8 A 🕐 🔁 🖓 🖞		OCD Artesia				
Form 3160-5 (March 2012)	UNITED STATES DEPARTMENT OF THE INTERIOR BUREAU OF LAND MANAGEMENT			0	DRM APPROVED MB No. 1004-0137 bires: October 31, 2014	
SUNDRY NOTICES AND REPORTS ON WELLS Do not use this form for proposals to drill or to re-enter an abandoned well. Use Form 3160-3 (APD) for such proposals.				6. If Indian, Allottee or	Tribe Name	
SUBMIT IN TRIPLICATE - Other instructions on page 2.				7. If Unit of CA/Agreement, Name and/or No. ROCK TANK UNIT

ROCK TANK UNIT NO. 4 1,650' FSL & 1,650' FEL, SEC 1, TWP 23S, RGE 24E EDDY COUNTY, NEW MEXICO

PLUG AND ABANDONMENT PROPOSED PROCEDURE:

RE: NMNM0272711; Rock Tank Unit No. 4 (API 3001520320) 1650' FSL & 1650' FEL, Sec. 1, T23S-R24E Eddy County, New Mexico

WELL DATA SHEET

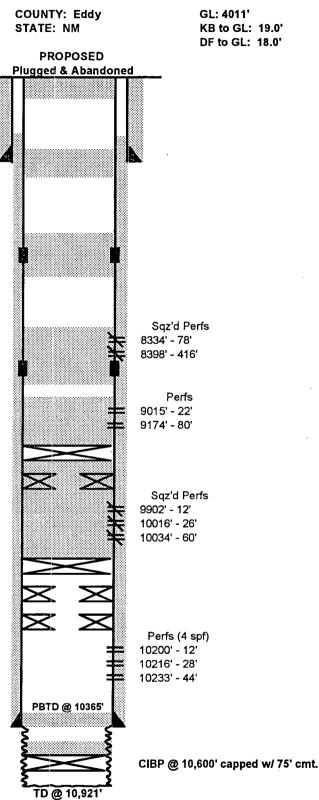
- 1. OK
- 2. WOC tag
- 3. OK
- 4. OK
 - a. Add plug, from 7841'-7661' (top Wolfcamp)
- 5. OK
 - a. Add plug, from 3860'-3720' (top Bone Spring)
- 6. OK
 - a. Add Plug, perforate @ 1570' and squeeze cement from 1570'-1470' (top Delaware). WOC tag.
- 7. Perforate @ 60' and squeeze cement to surface leaving casing full.
- 8. OK
- 9. OK
